ADDENDUM #05

Project Name: Central County Fire & Rescue – HQ, Training, Maintenance

Project Number: 23121

Date: October 28, 2025

SEWER PROFILE
 SCALE:
 HORIZONTAL: 1"=20'
 VERTICAL: 1"=5'

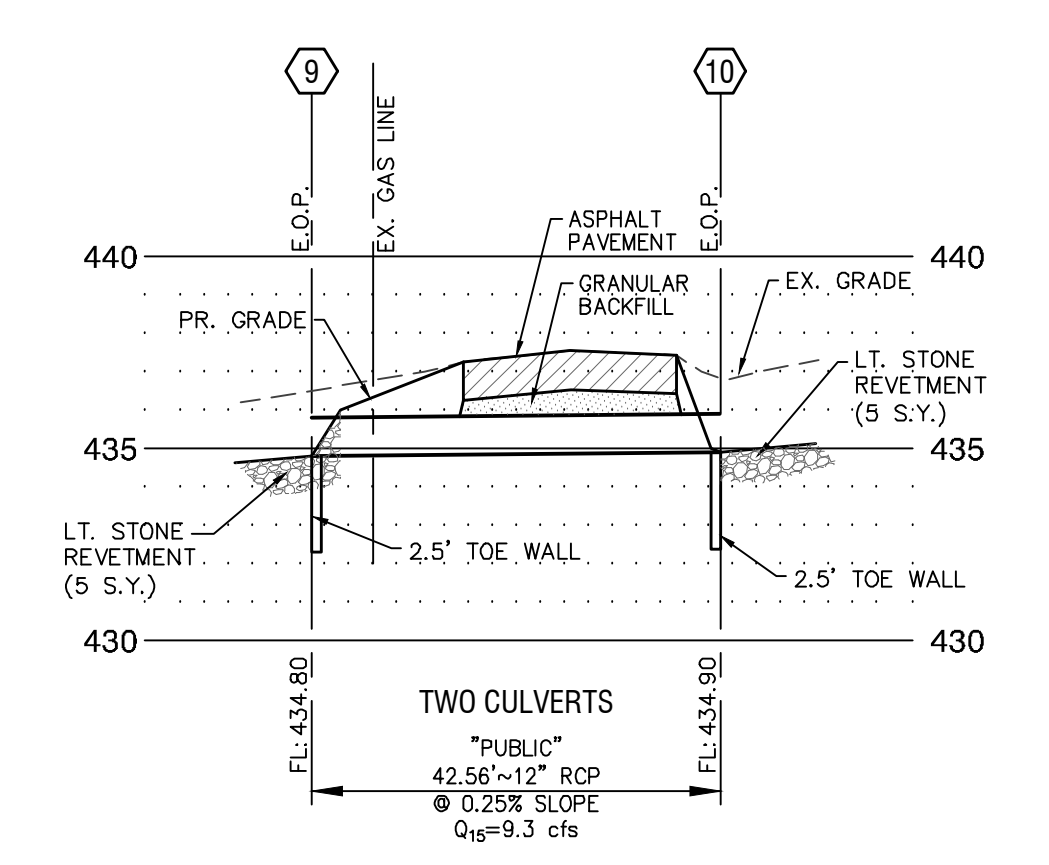
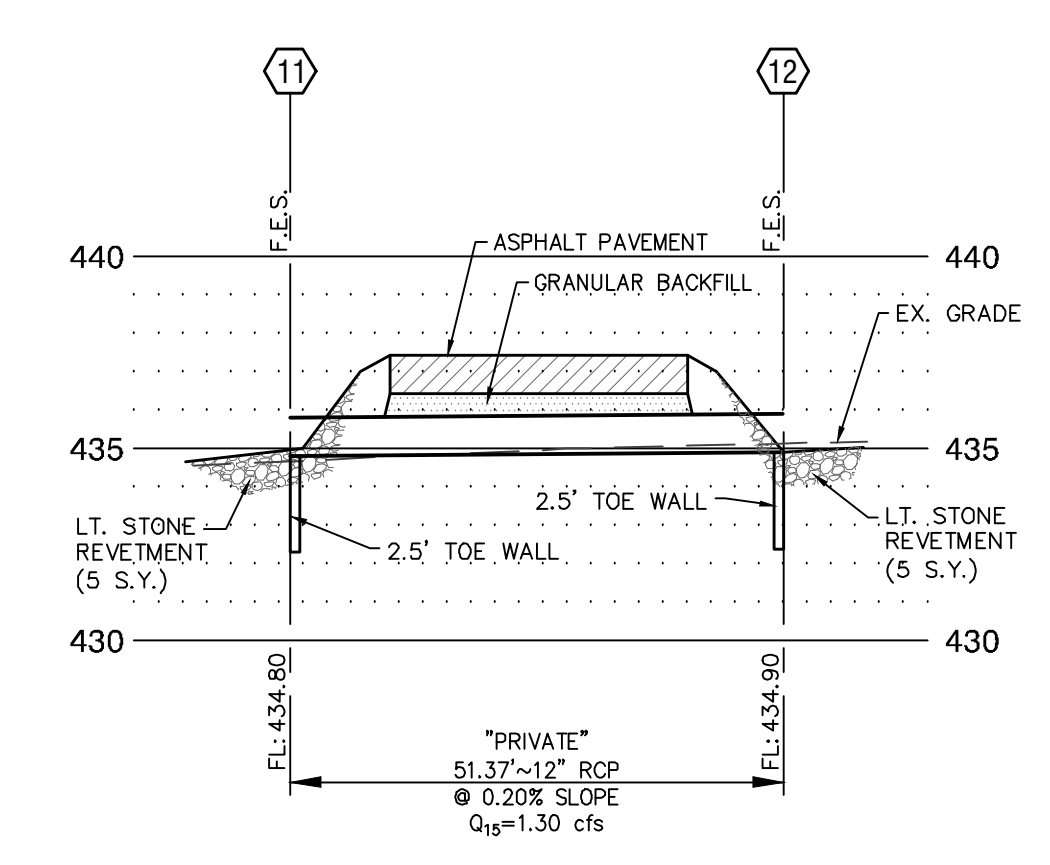
1. Sheet C5.0 – Site and Grading Plan
 - a. **Added Force Main to the drawing**
 - b. **Reference attached Revised Sheet.**
2. Sheet C6.0 – Site Geometry and Utility Plan
 - a. **Moved 6" water line to the Northwest of the Maintenance Building**
 - b. **Reference attached Revised Sheet.**
3. Sheet C7.0 – Sewer Profiles
 - a. **Added sewer Structure and profile to drawing**
 - b. **Reference attached Revised Sheet.**

Sheet No.
A421

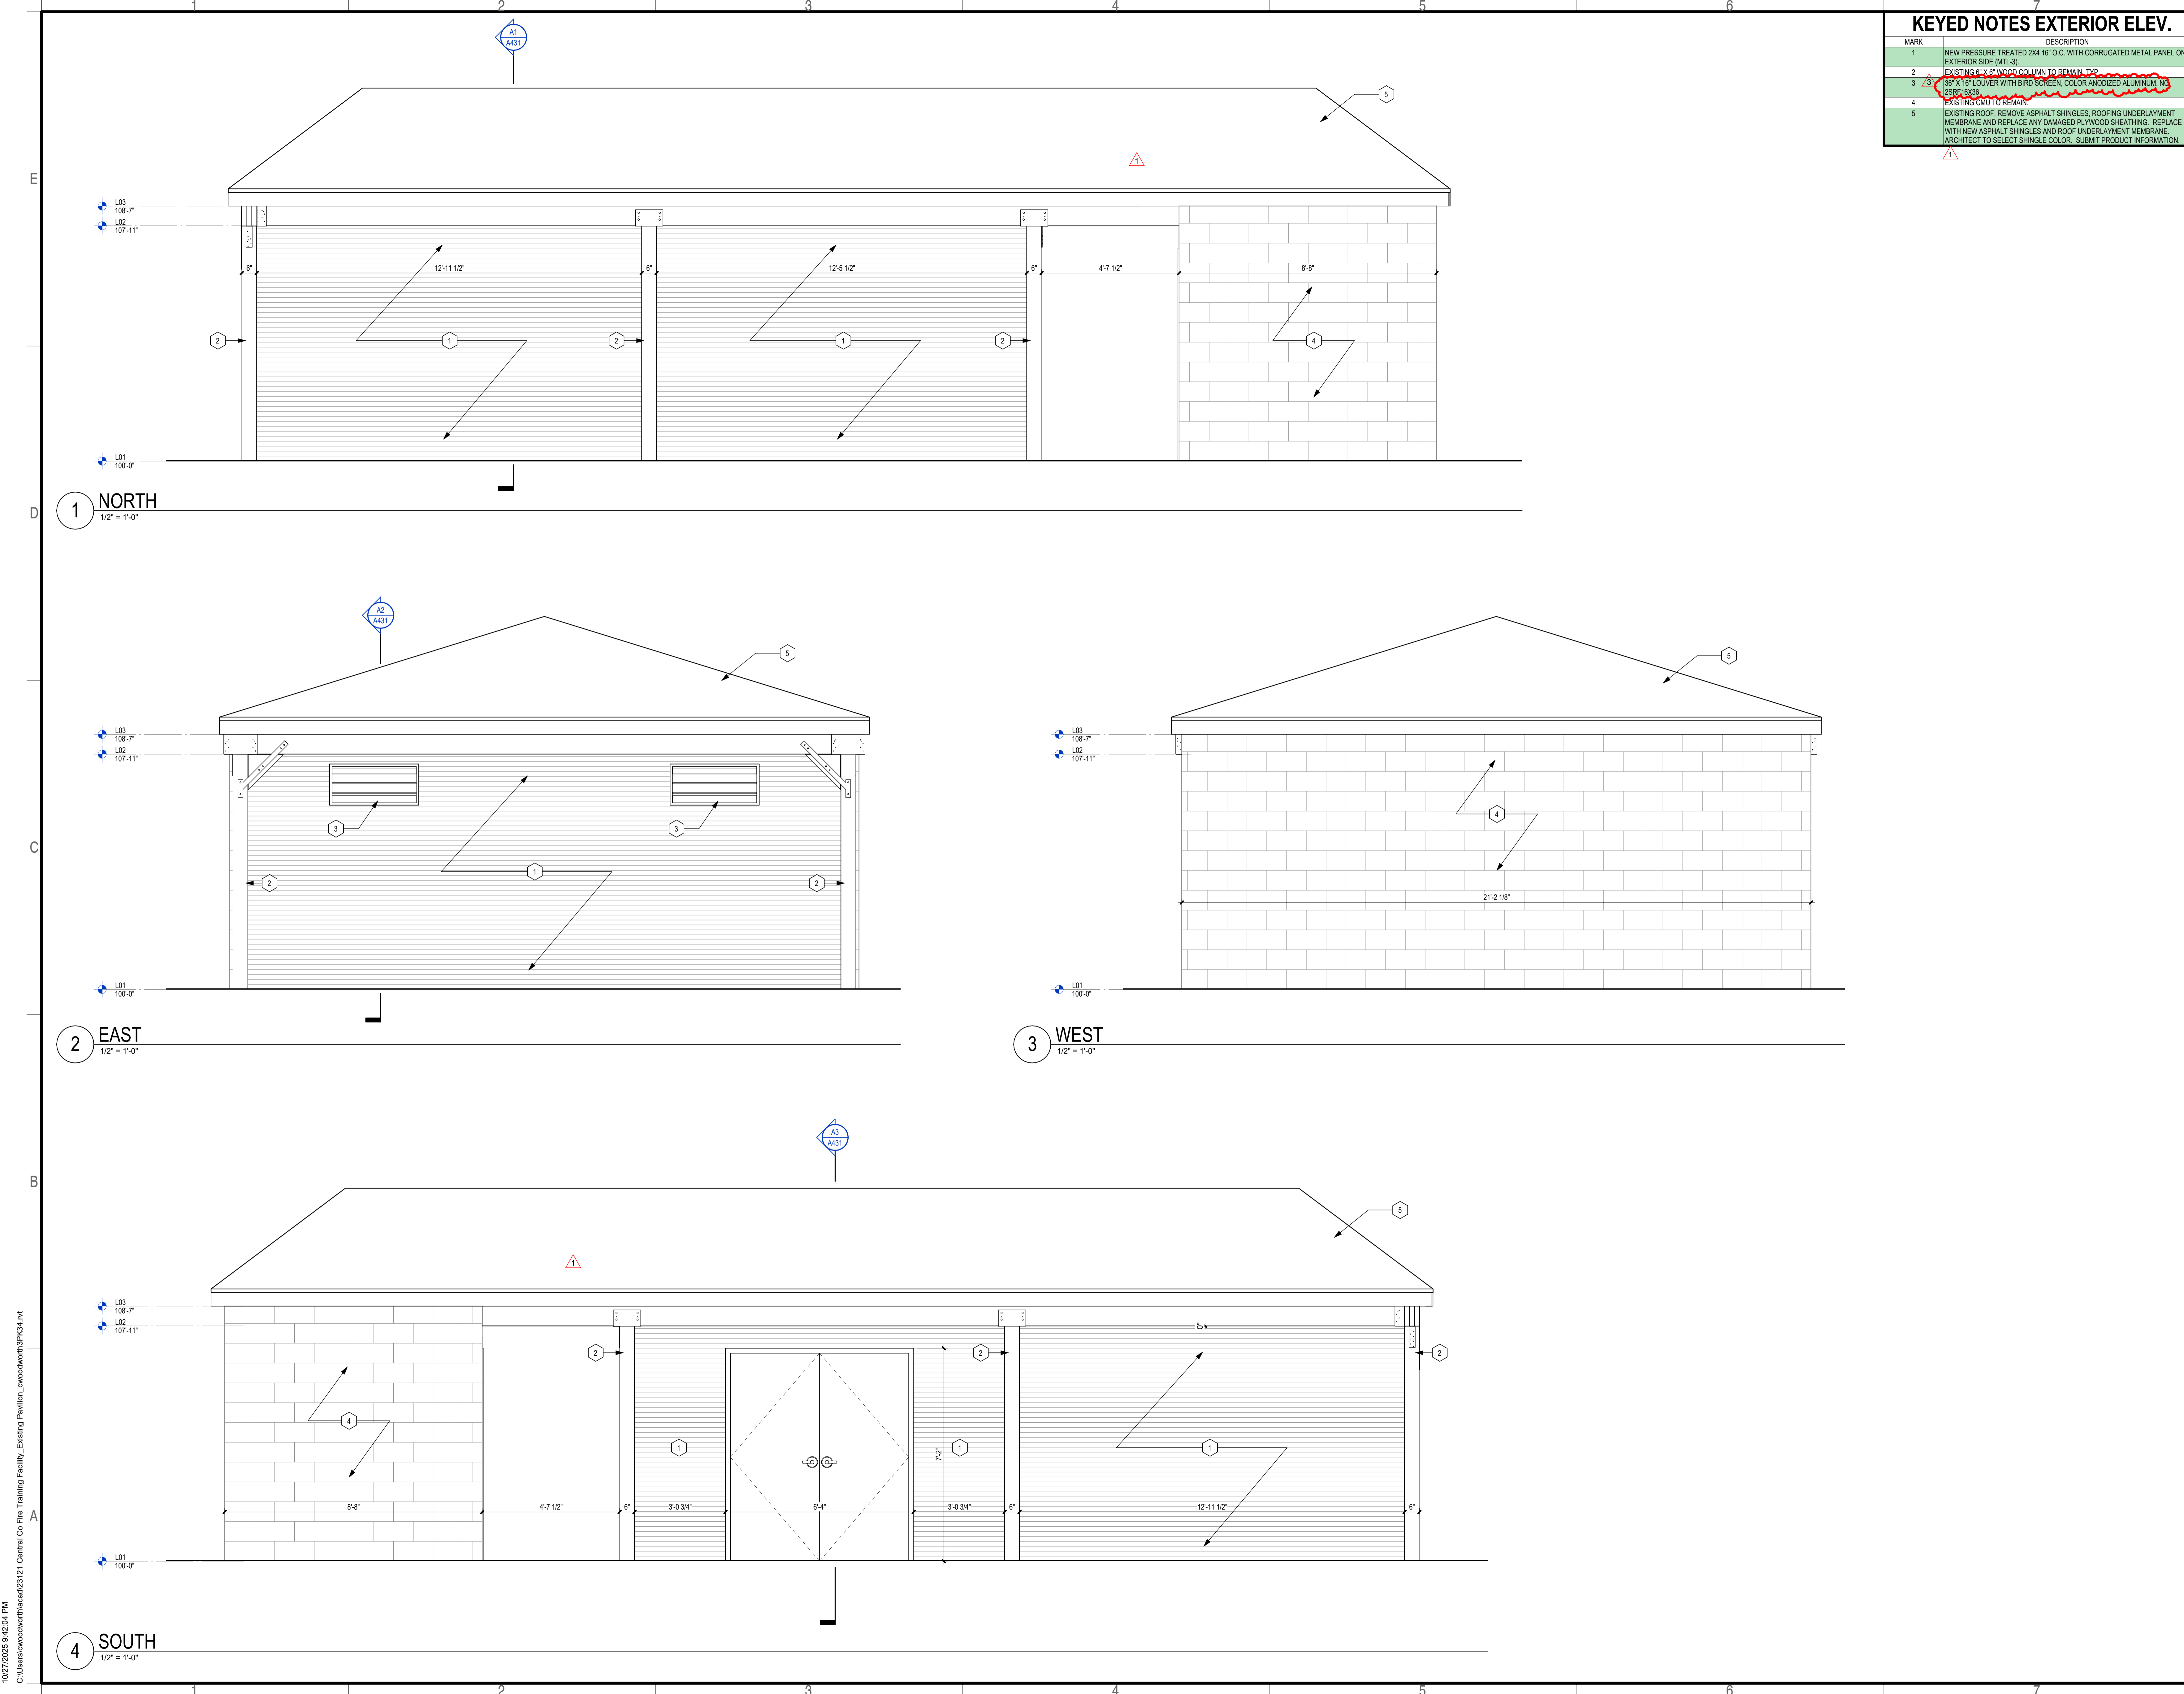
5. In Existing Pavilion, plan page A411, note #1 / A413, note #3 / A421, note #3 and A431, detail Section A2 refer to (4) New Aluminum Louver/Air Vents. Do you have a schedule for these Louvers w/ Make, Model, Size and color? The Opening for the 35" Aluminum Fixed Blade Angle Louvers are 36" x 16-5/8". What trade is to furnish them? What BP# will it go under?
 - a. **Response: 16" X 36" Extruded Aluminum Louver with Bird Screen – Storm Proof Louver, Model 2SRF16x36. Color Anodized Aluminum. See sheet A421.**

1. A411 – Floor Plan
 - a. **Edit keyed note 1. 36” x 16” LOUVER WITH BIRD SCREEN, COLOR ANODIZED ALUMINUM, MODEL 2SRF16X36**
 - b. **Reference attached Revised Sheet.**
2. A421 - Exterior Elevation
 - a. **Edit keyed note 3. 36” x 16” LOUVER WITH BIRD SCREEN, COLOR ANODIZED ALUMINUM, MODEL 2SRF16X36**
 - b. **Reference attached revised sheet.**

Project No. 23121
 Sheet No. **FP221**
 Date: 09/16/2025

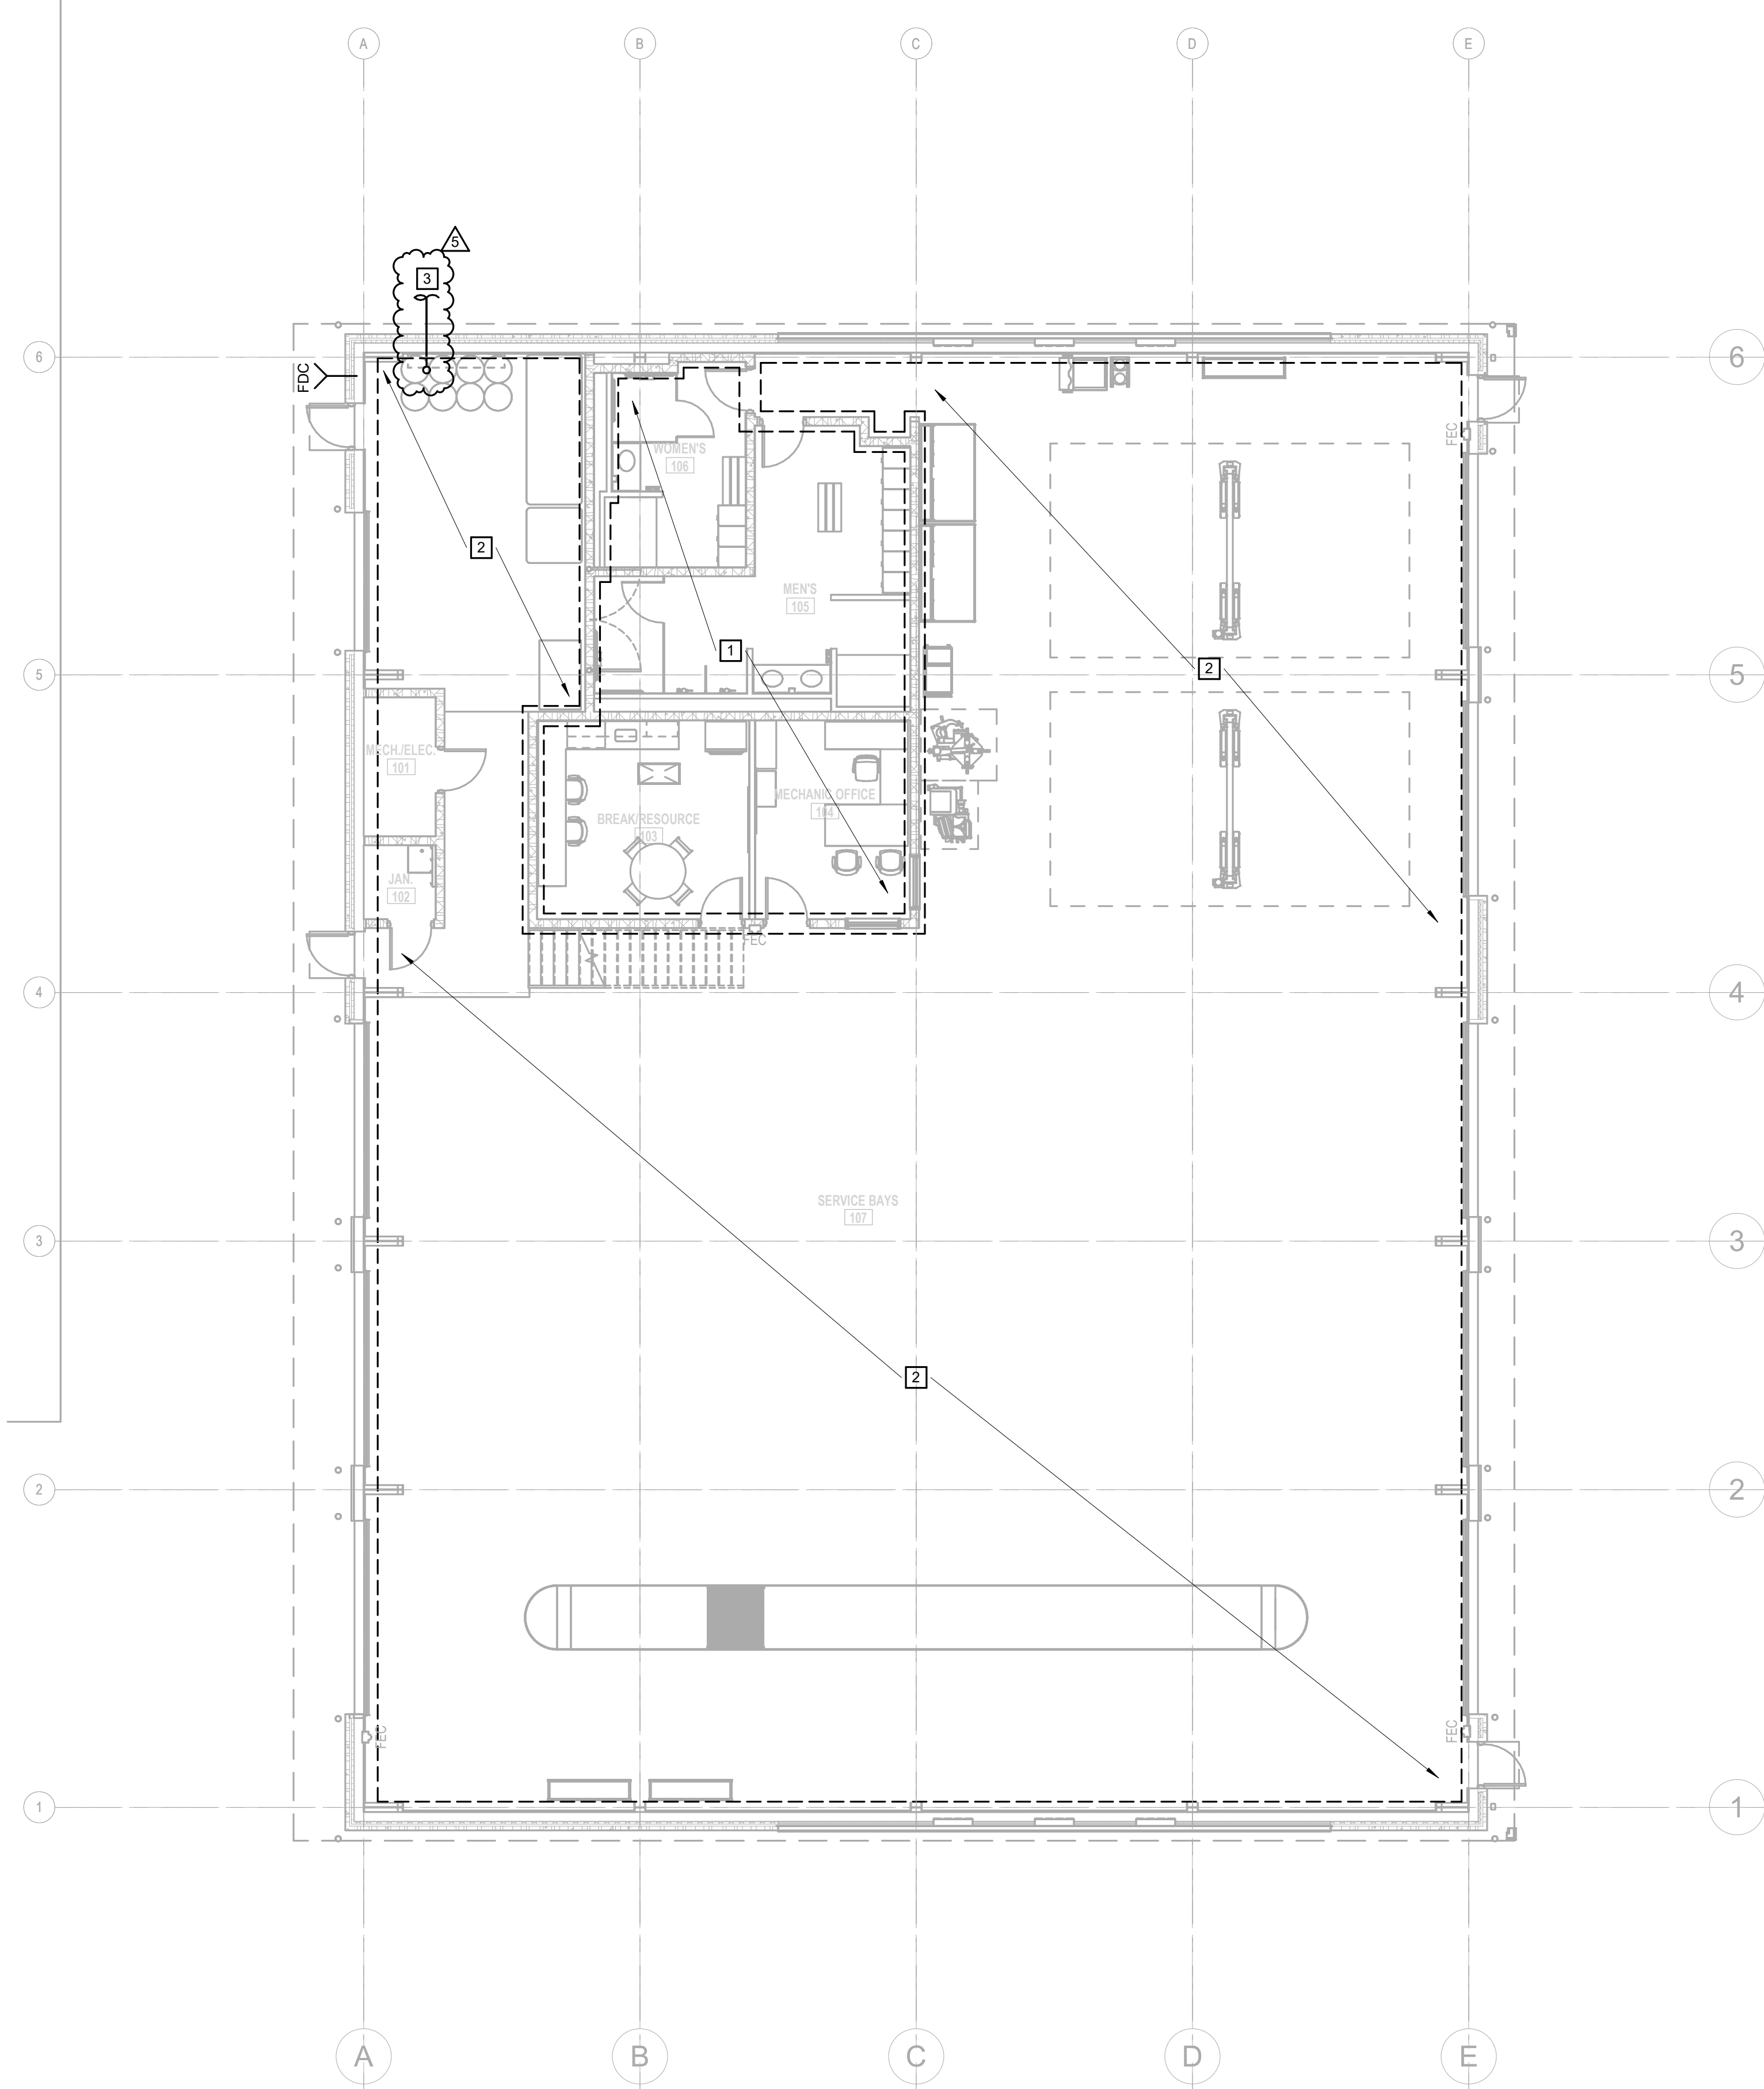
1. Sheet FP221 – Maintenance Fire Protection Plan
 - a. **Relocated fire protection sprinkler main entrance.**
